# PRELIMINARY & FINAL DRAINAGE PLAN

## CARRIAGE MEADOWS SOUTH AT LORSON RANCH FILING NO. 2

PUDSP-19-005

## Summary of Comments on Microsoft Word - 100.046- PDR&FDR

SHEET: JUNE 28, 2019  
 PROJECT NO. 100.046  
 SHEET NUMBER: C6.1  
 TOTAL SHEETS: 21

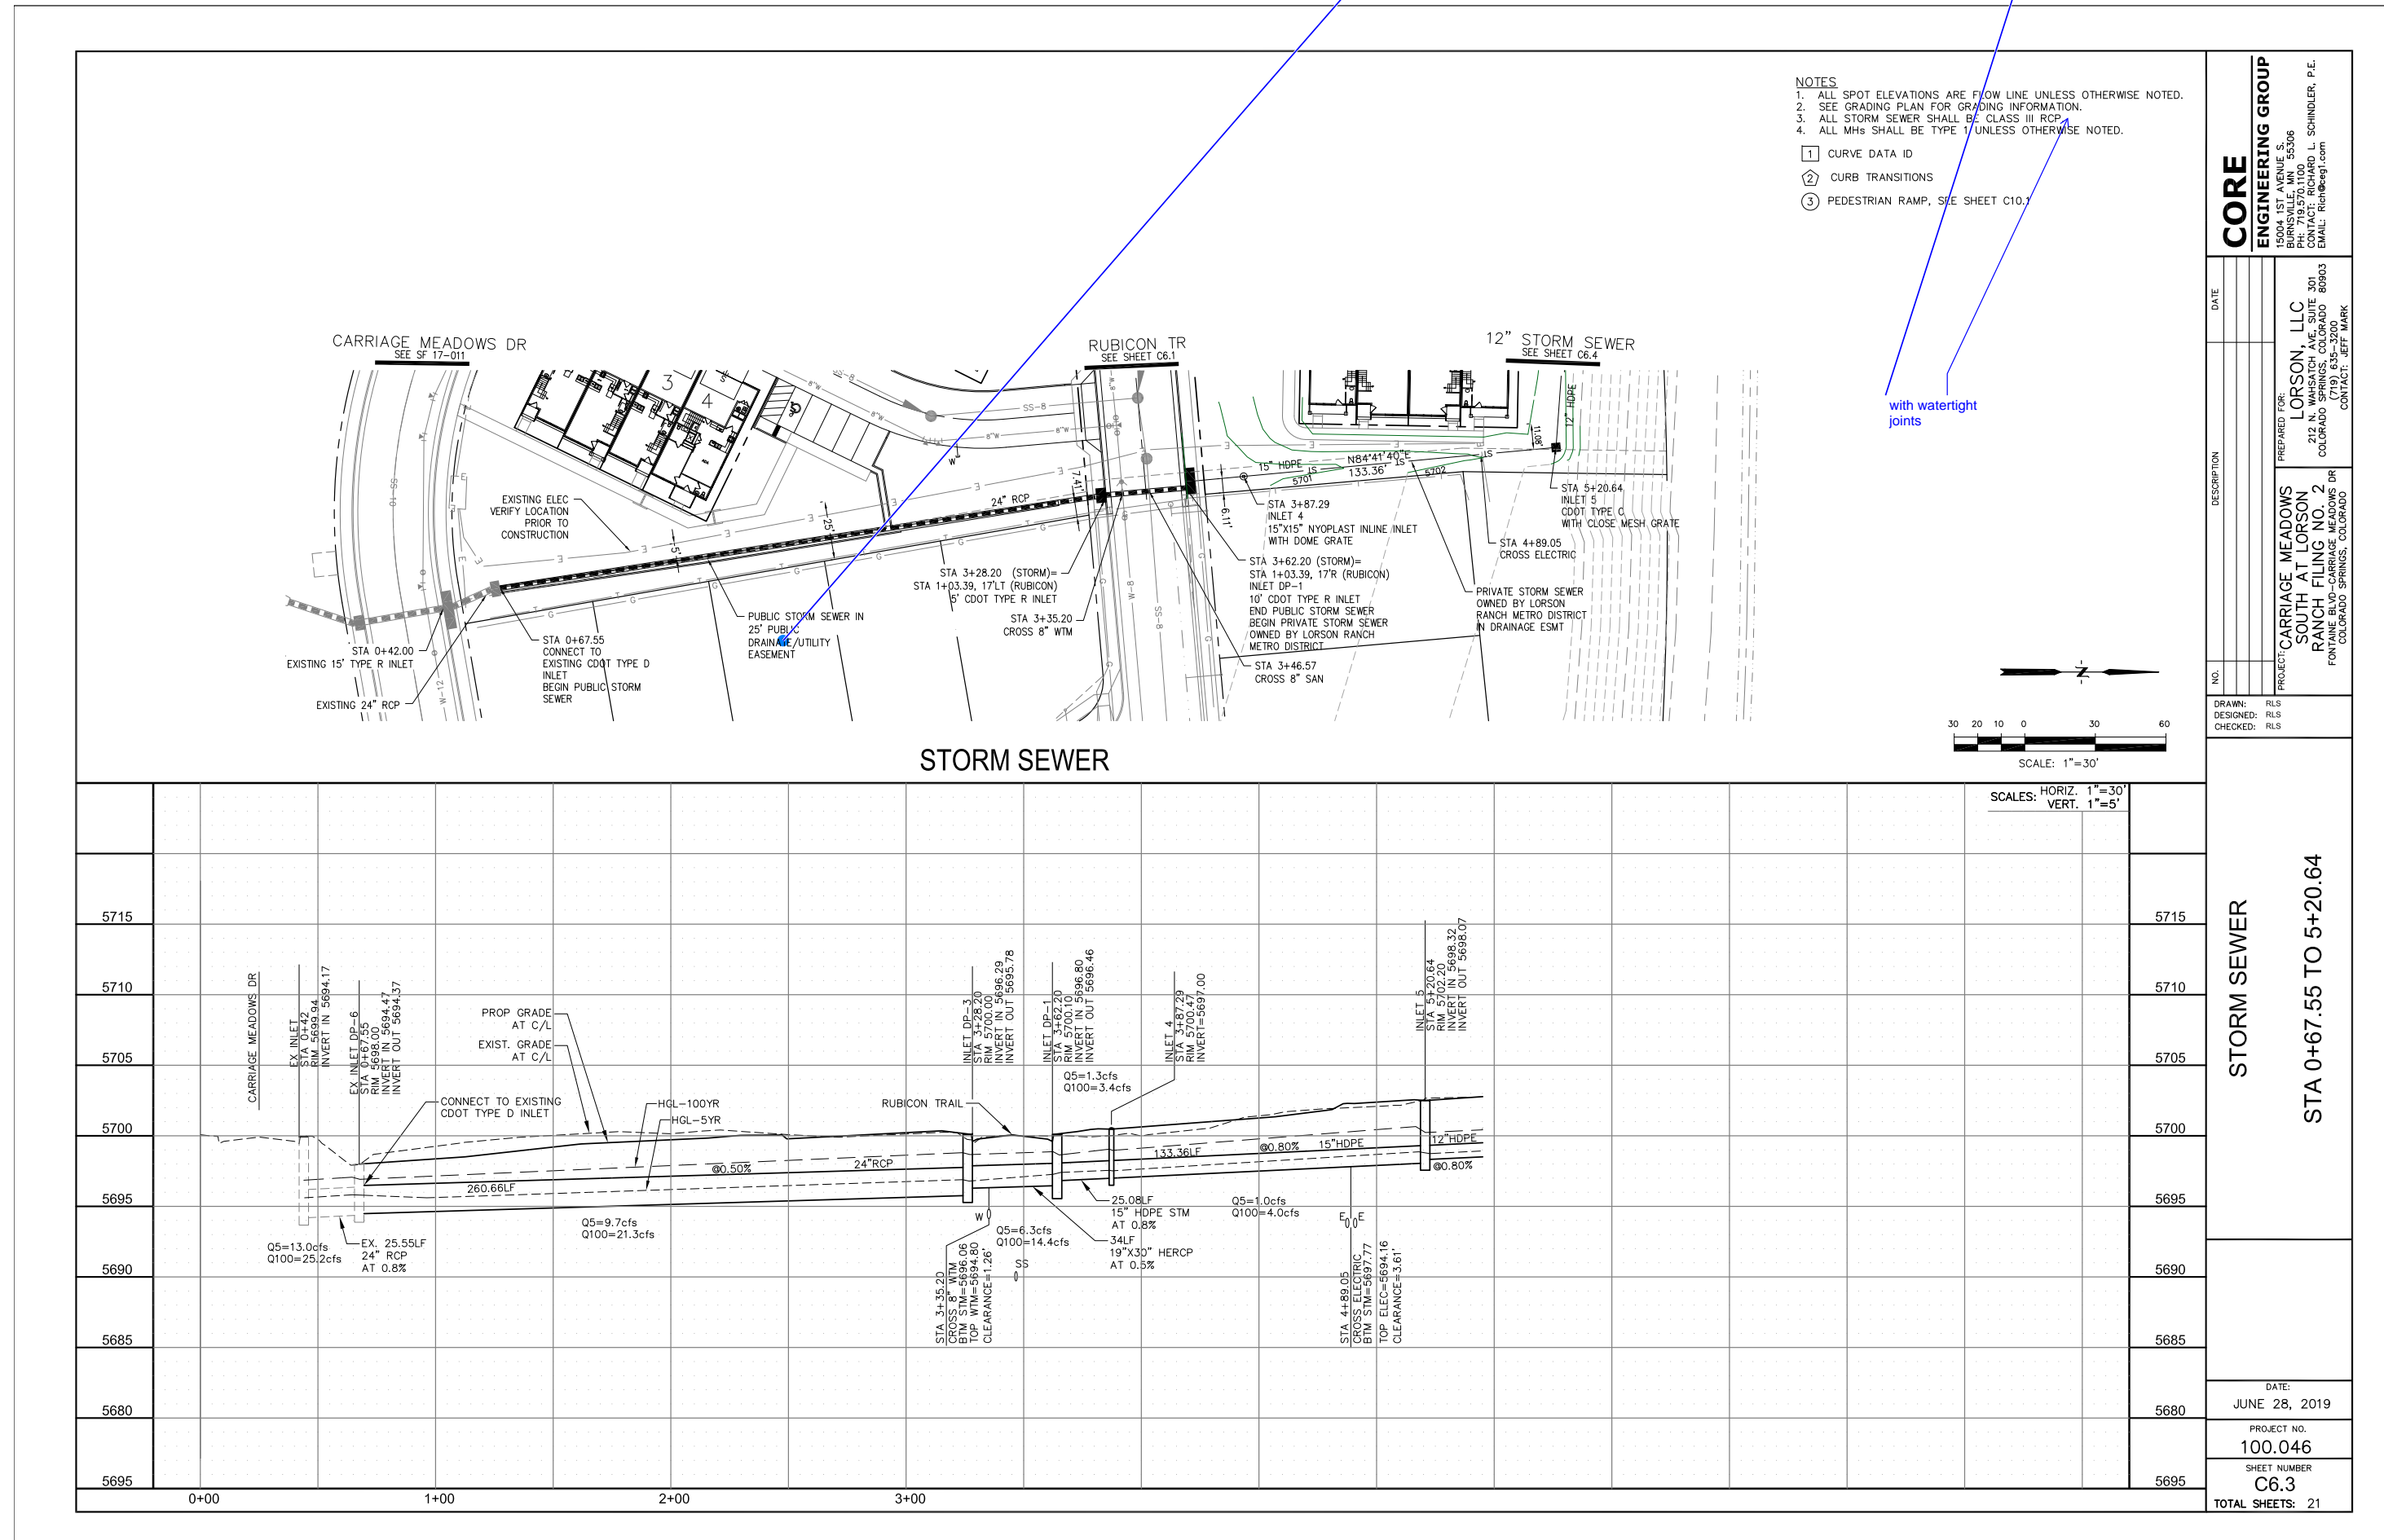
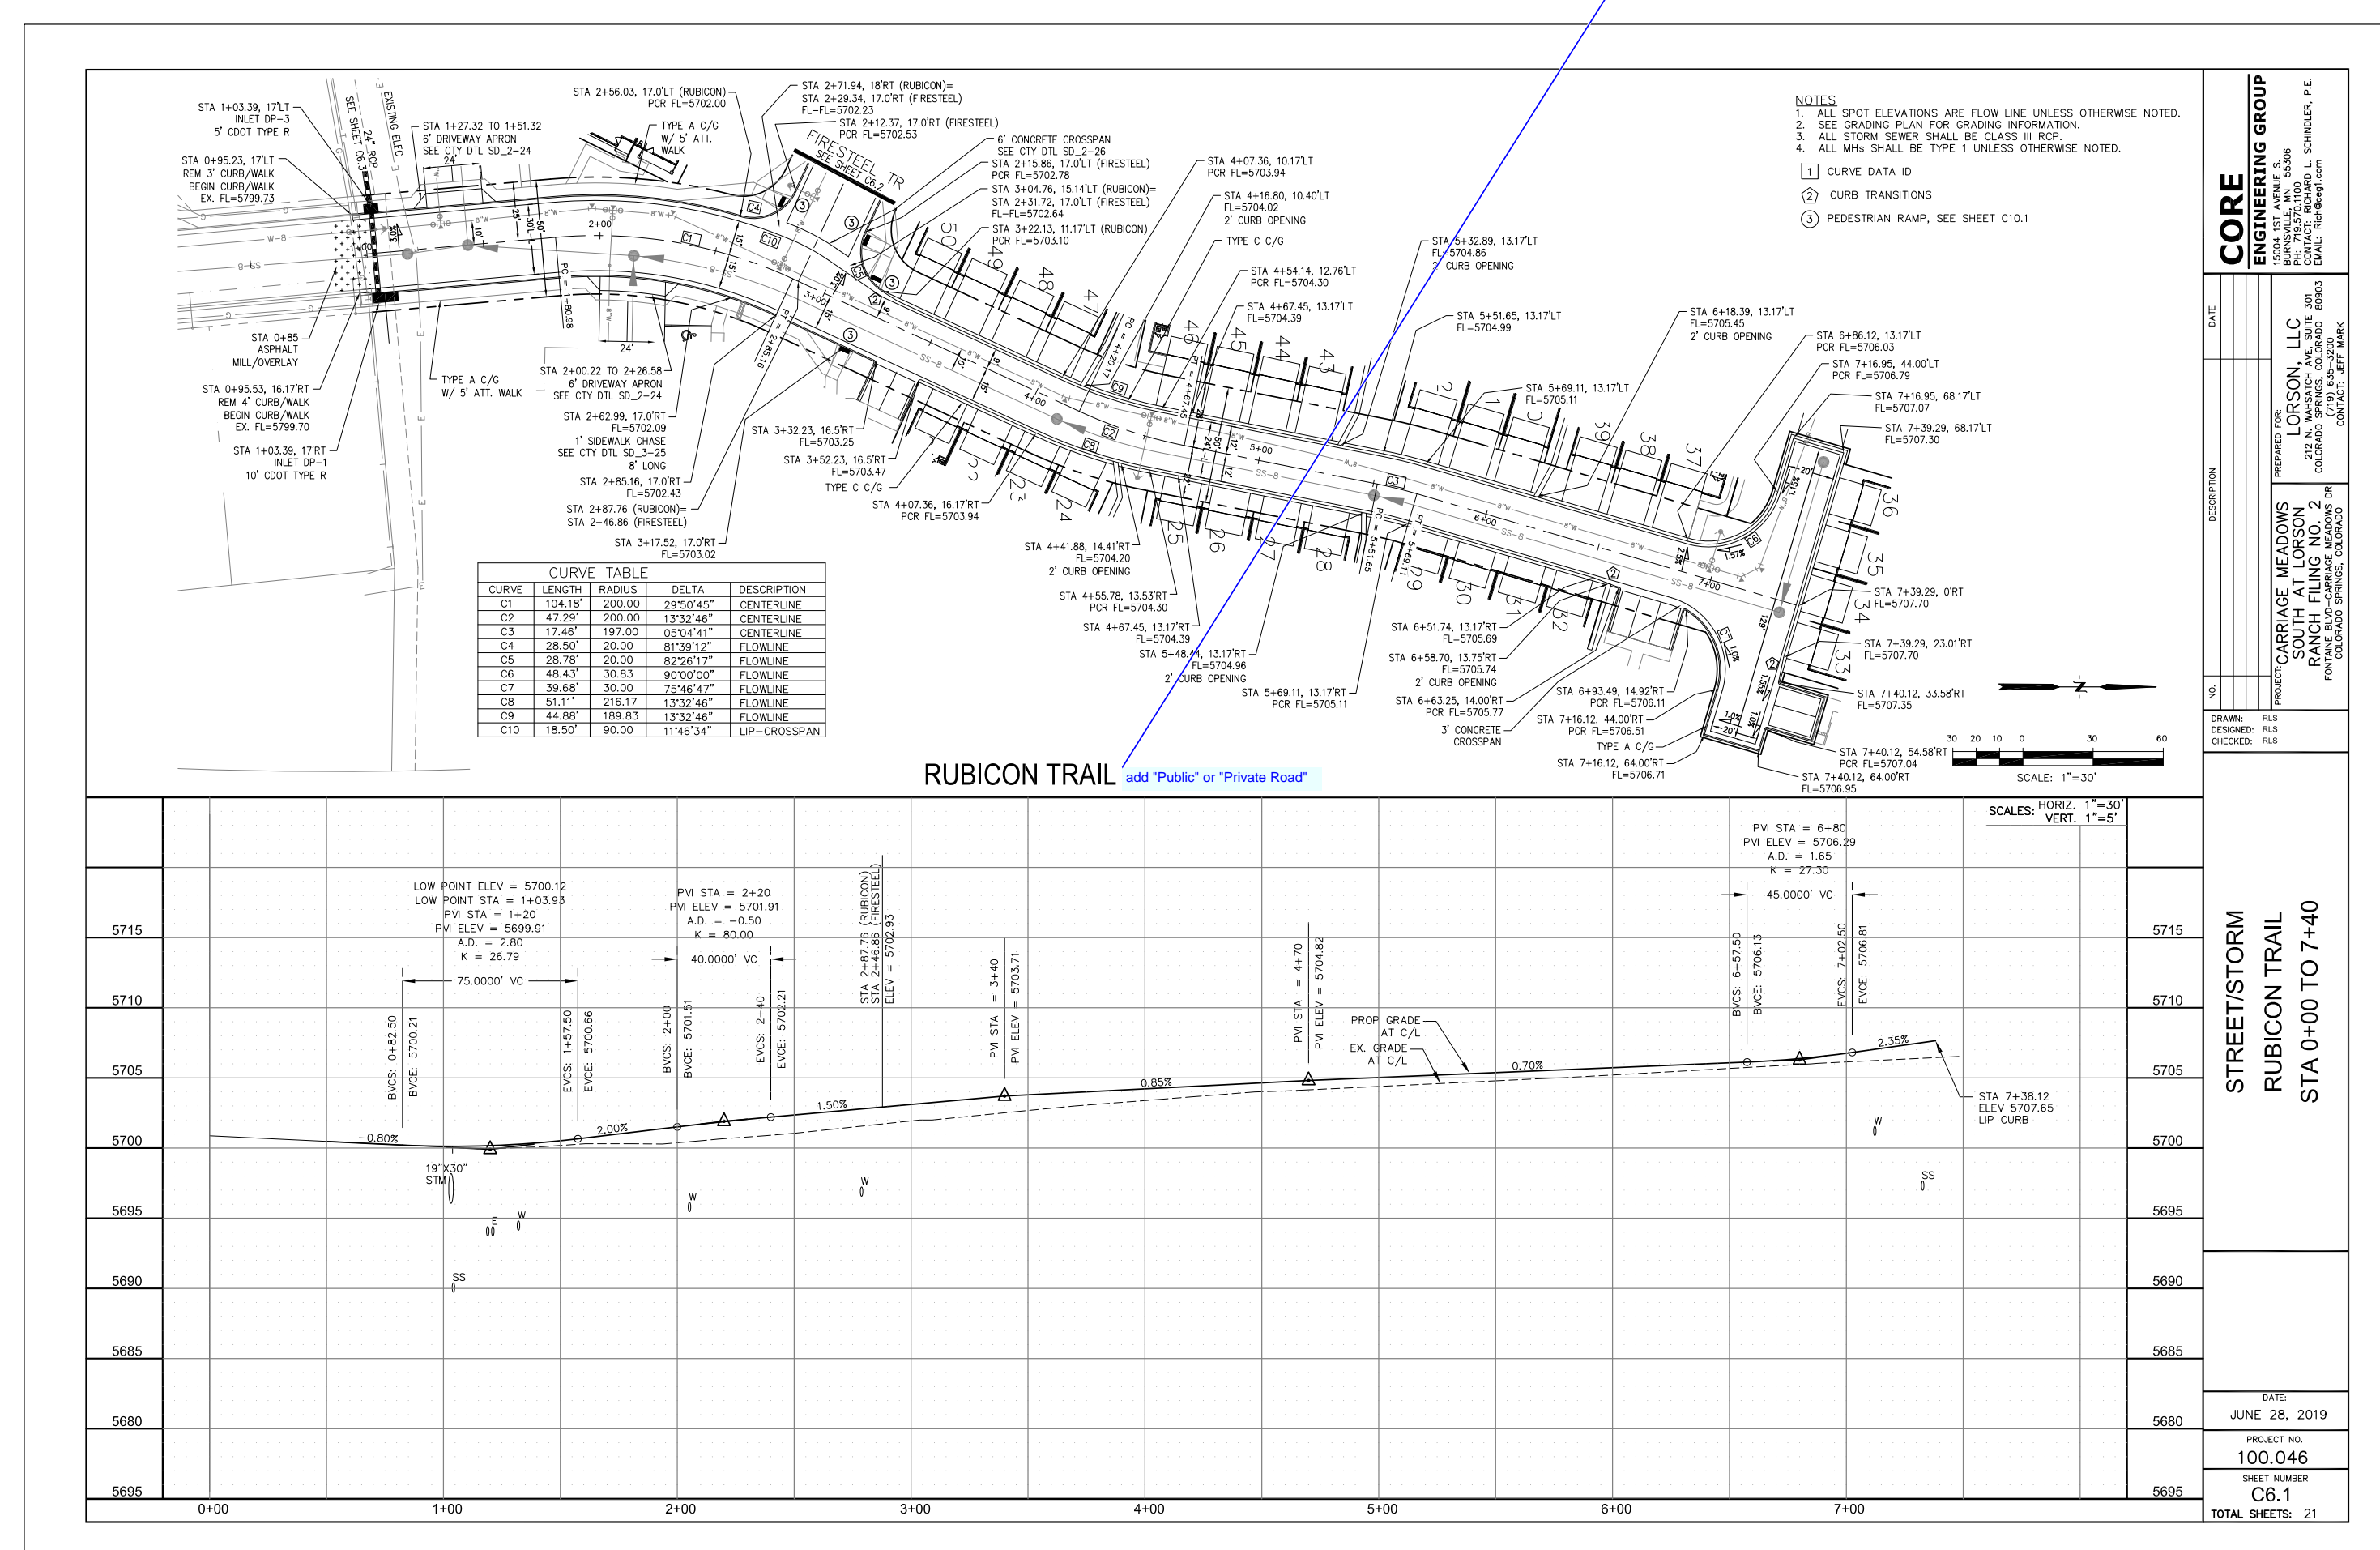
- Author: dhdice Subject: Line Date: 8/23/2019 9:40:43 AM
- Author: dhdice Subject: Snapshot Date: 8/30/2019 12:21:38 PM
- Author: dhdice Subject: Highlight Date: 8/30/2019 12:21:27 PM  
provide improvements
- Author: Richender Subject: Sticky Note Date: 10/14/2019 7:27:18 AM  
Please turn lane provided
- Author: dhdice Subject: Callout Date: 8/23/2019 9:47:14 AM
- Author: Richender Subject: Sticky Note Date: 10/14/2019 7:27:21 AM  
Please turn lane

Show the curb location per the Carriage Meadows South PUD/SP (PUDSP-16-002)

Author: dlabice Subject: Callout Date: 8/23/2019 10:49:49 AM  
See other comments regarding completion of Carriage Meadows Drive.  
Author: Kufender Subject: Sticky Note Date: 10/14/2019 9:17:11 AM  
11 km 10km  
Author: dlabice Date: 8/22/2019 4:16:31 PM
